# Sheringham Shoal and Dudgeon Offshore Wind Farm Extension Projects

Apportioning and HRA Updates Technical Note  
(Revision E) (Clean)

Document Reference: 13.3

Table 5-2: Natural England consultation summary (Based on Rev B Note [REP2-036] at Deadline 3, received May 2023)

Title:  
Figure 3 Potential exclusion areas from SEP to avoid impacts to Greater Wash SPA Red-throated Diver populations

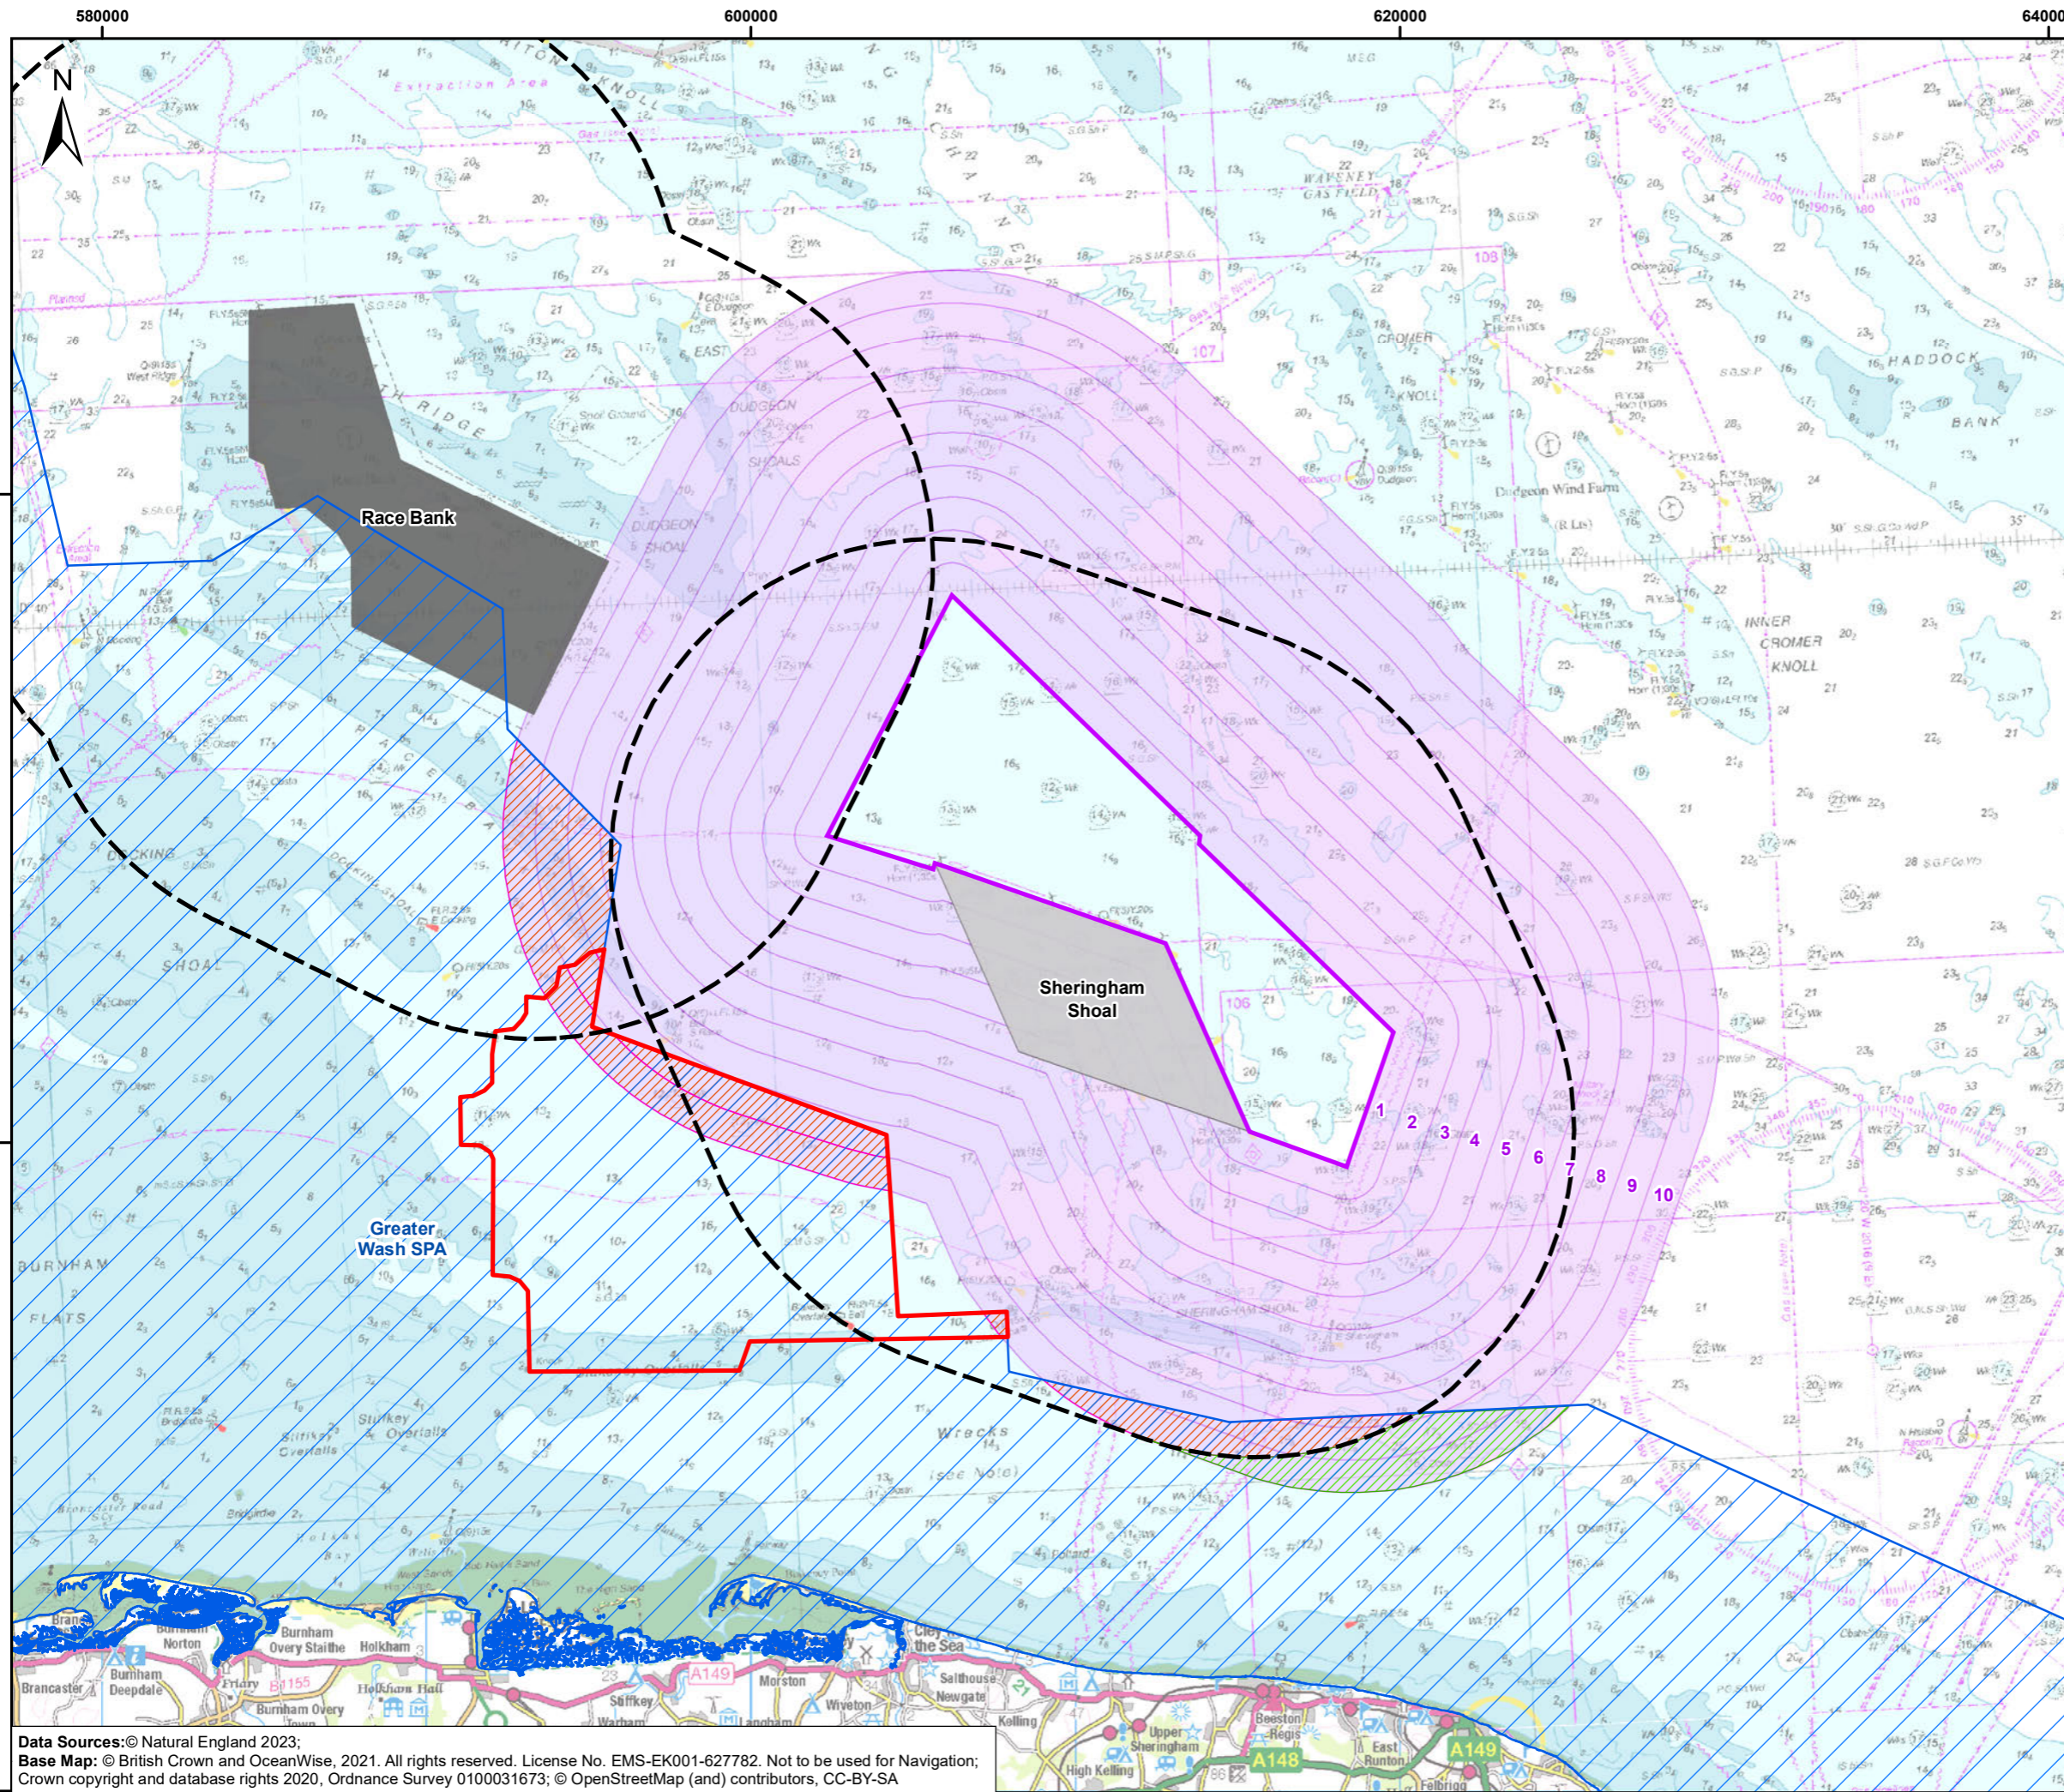
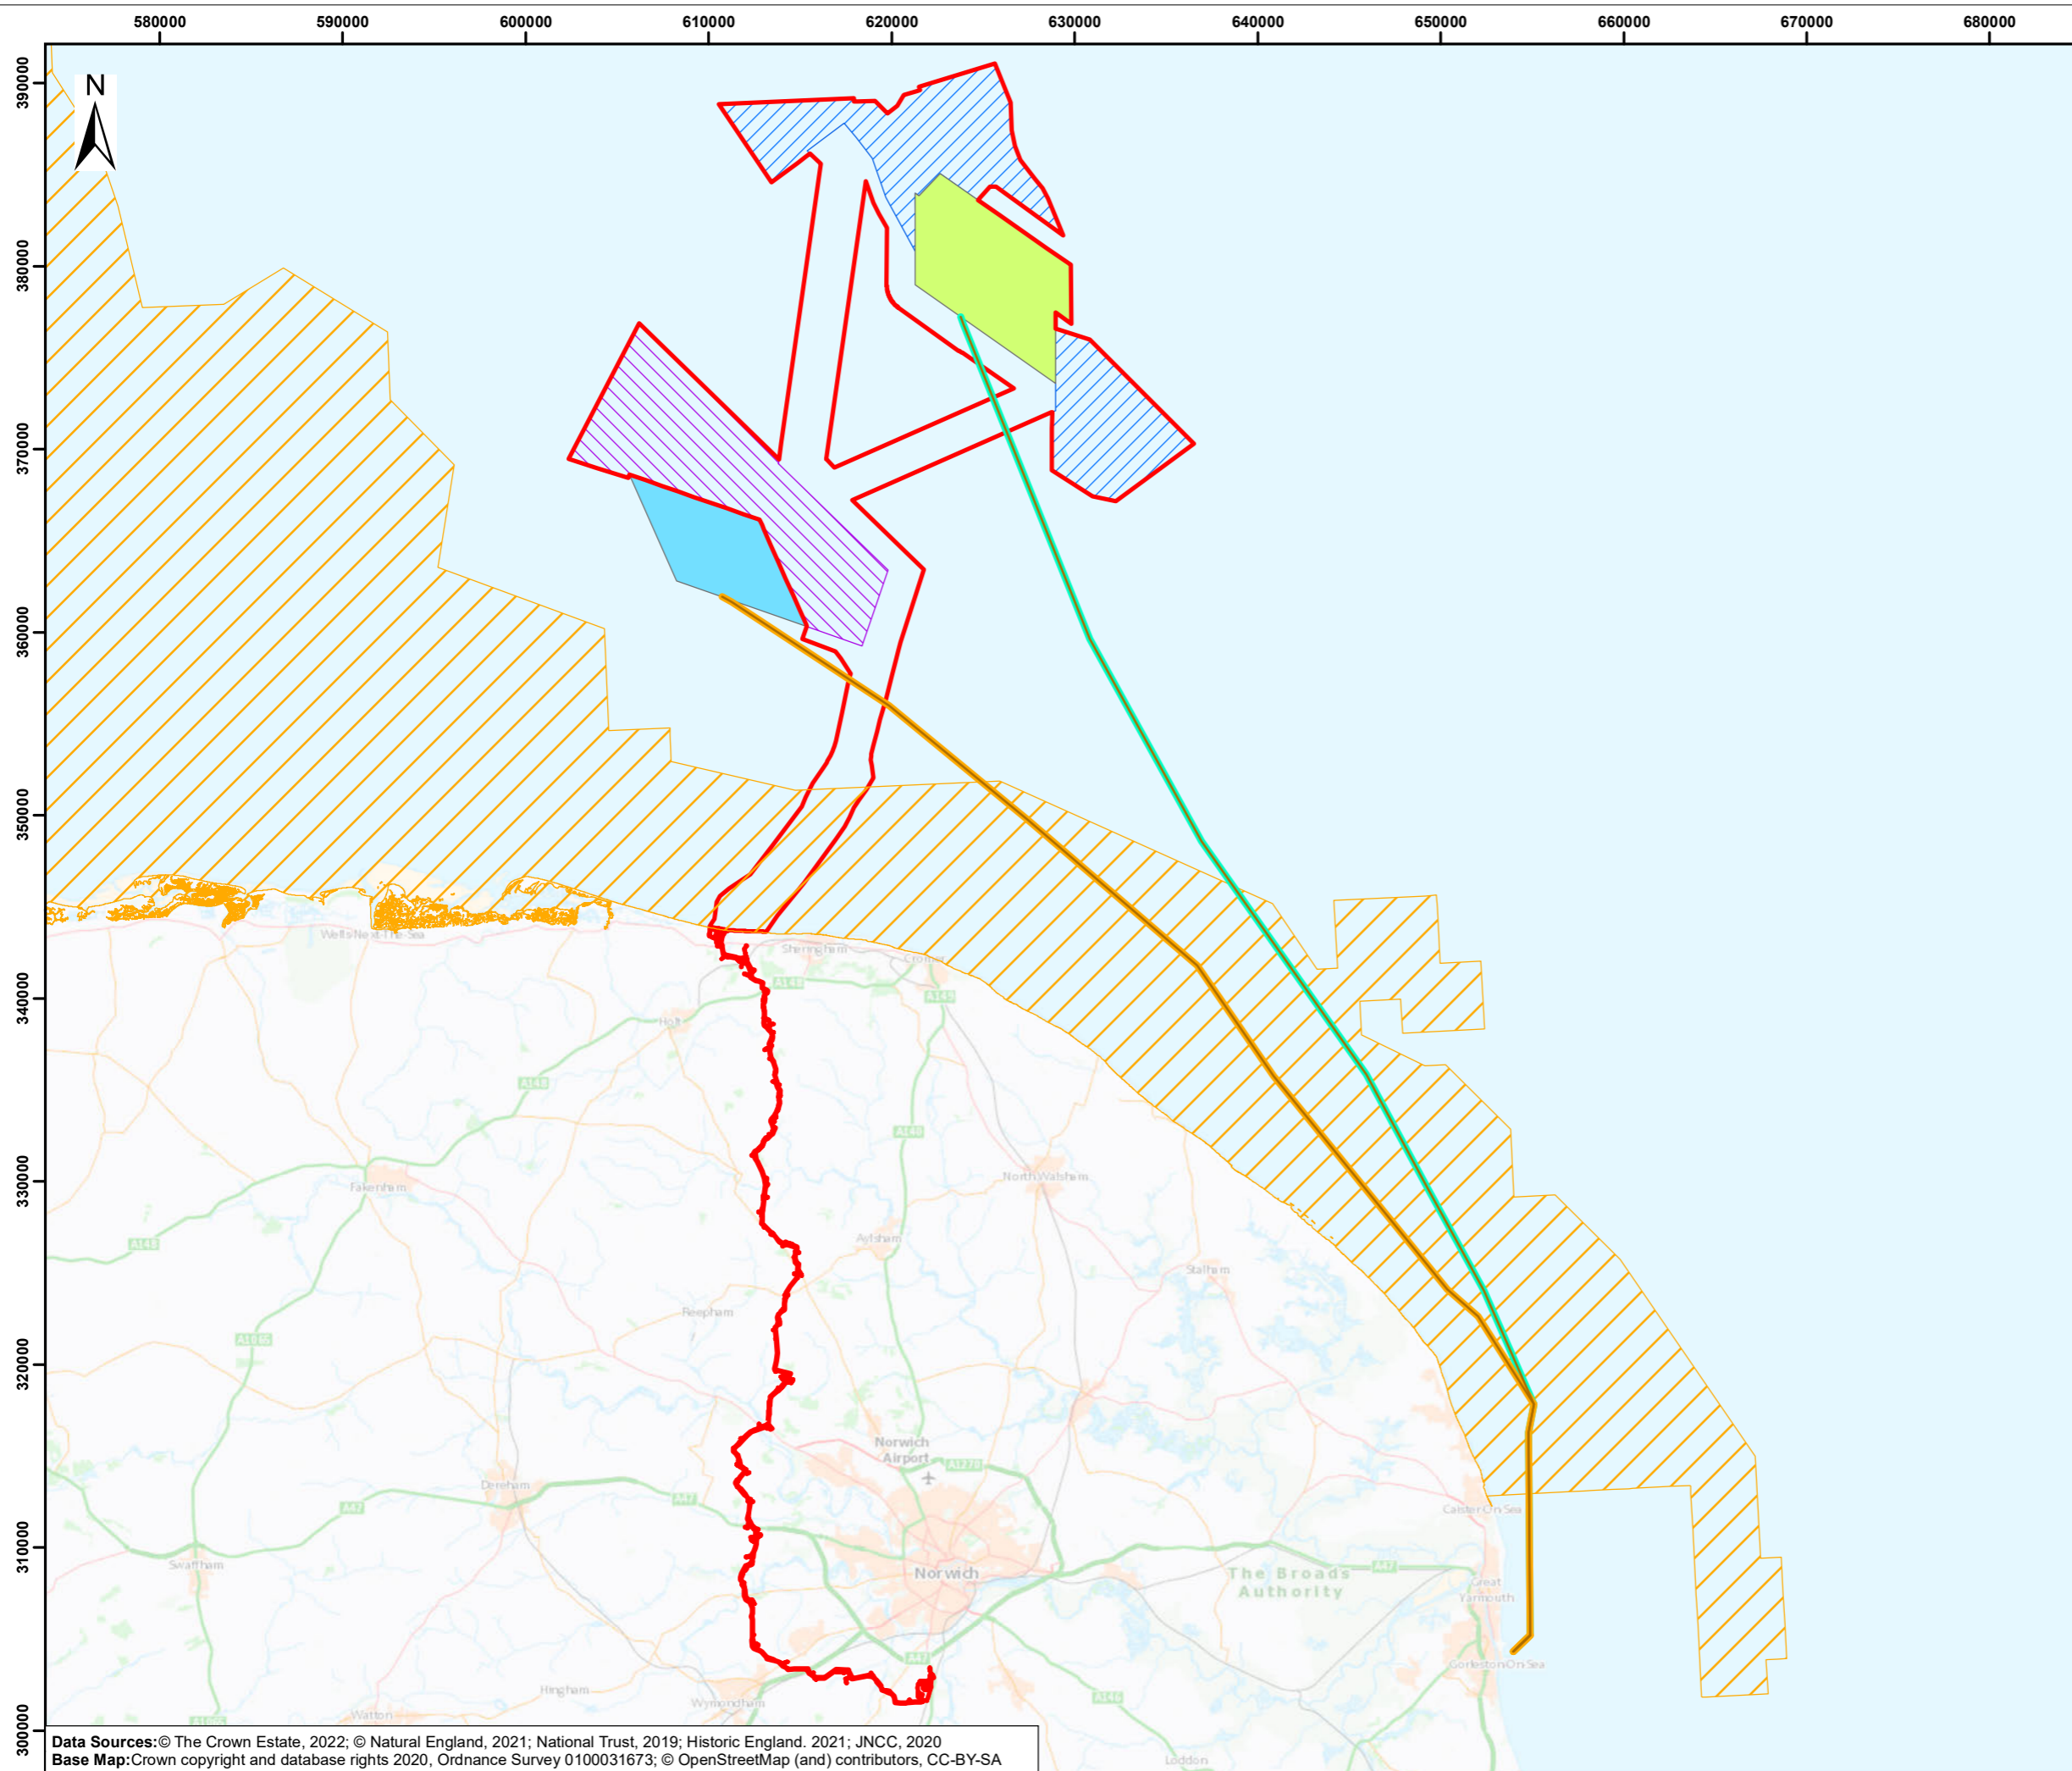
108. In response to Natural England feedback on the assessment [RR-063; REP3-143], in June 2023 the Applicant considered (without prejudice) areas within the SEP wind farm site where turbines could be excluded to reduce the overlap between the 10km buffer and GW SPA. Four approaches for exclusion areas were considered, with buffer/SPA overlap and effective area of displacement calculations presented for each approach – see [Section 14.2.2](#). In addition, further information has also been provided on potential displacement effects of O&M vessels passing through the SPA ([Section 14.2.3](#)).

124. Figure 3, which all result in a reduction of the total area of GW SPA impacted; the areas where an effect would be avoided are shown shaded dark pink on
- 125.
- 126.
127. Figure 3. For Approach 1, the impacted area is reduced to zero, but for other approaches the impacted area is reduced from 1.77% (i.e. that calculated using the full SEP wind farm site boundary) to between 0.69% (Approach 3) and 1.36% (Approach 4); the effective area of displacement would be reduced from 0.56% to between 0.23% (Approach 3) and 0.44% (Approach 4).
128. The Applicant considers that Approaches 1-3 do not present justifiable mitigation options given that these do not take into account the existing effect of SOW and Race Bank OWFs and/or the presence of the red-throated diver MCA. **Table 14-5** also sets out the effective impacted area, taking into account areas outside of the

129. As noted in **Section 1**, following discussions with Natural England on 14 July 2023, the Applicant has committed to implementing Approach 2, as set out in **Paragraph 119**, top right of **Figure 3**, and in **Table 14-5**. This excludes areas of SEP that are located within 10km of GW SPA, where these parts of the SPA are not currently within 10km of the existing SOW and Race Bank OWFs. Under this approach, the total area of the SPA within 10km of SEP would be 43.41km<sup>2</sup>, or 1.23% of the SPA. However, taking into account areas within 10km of SOW and Race Bank, the total area effectively reduces to zero (**Table 14-5**).
